17-37 WILLIAM ROAD | LONDON

SECTION 96A APPLICATION: DESIGN & ACCESS STATEMENT

24158-56T-P8-XXX-R-A-001-P04
05.02.2025

A / Proposed East Elevation

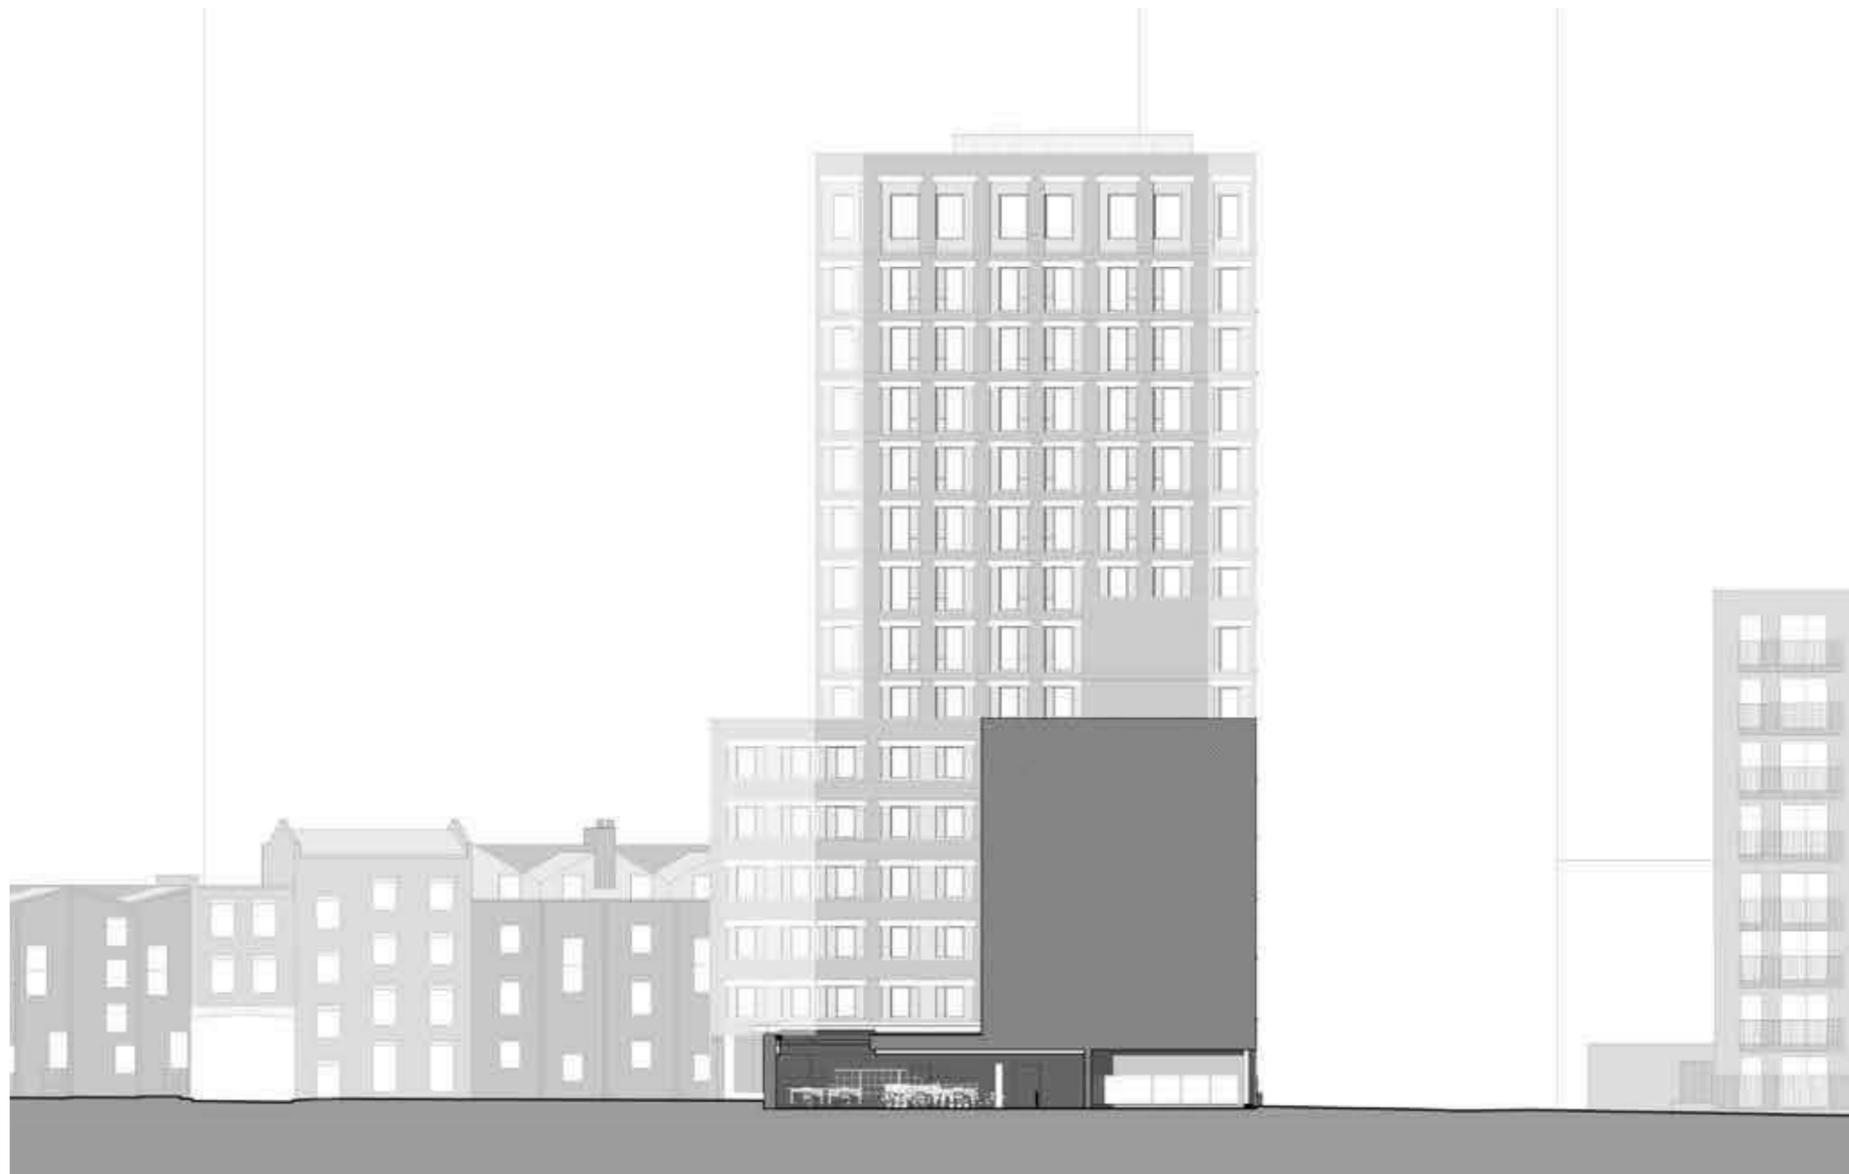
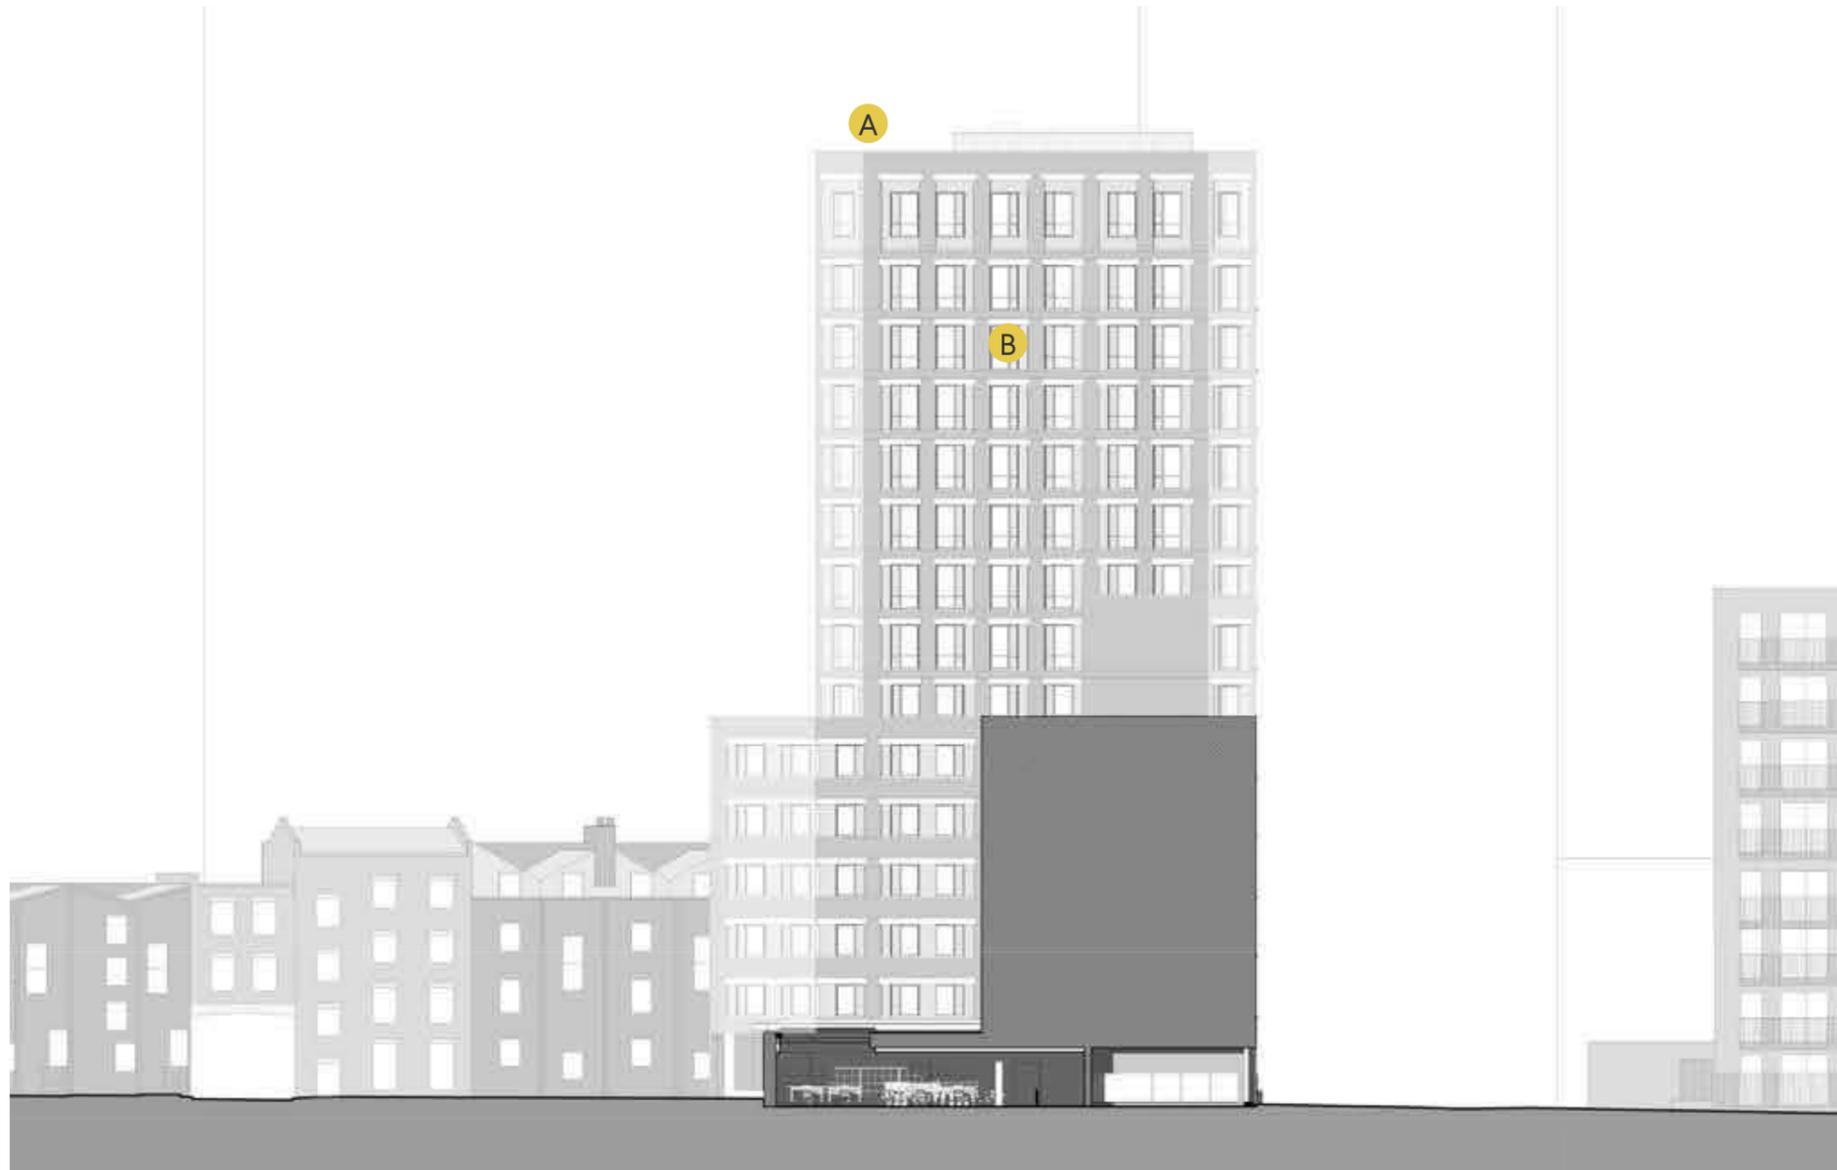
- A. Verticality of elevation is retained with the consented facade's pier widths and spacing remaining unchanged.
- B. Window bays are mirrored in certain locations to accommodate internal adjustments as described previously. Window openings remain as consented with Window, Vent and Recessed Brick Panel layout adjusted.

The areas affected from alterations discussed above are highlighted adjacent in yellow. The retained alignment of piers is clearly retained indicated by the dashed yellow line.
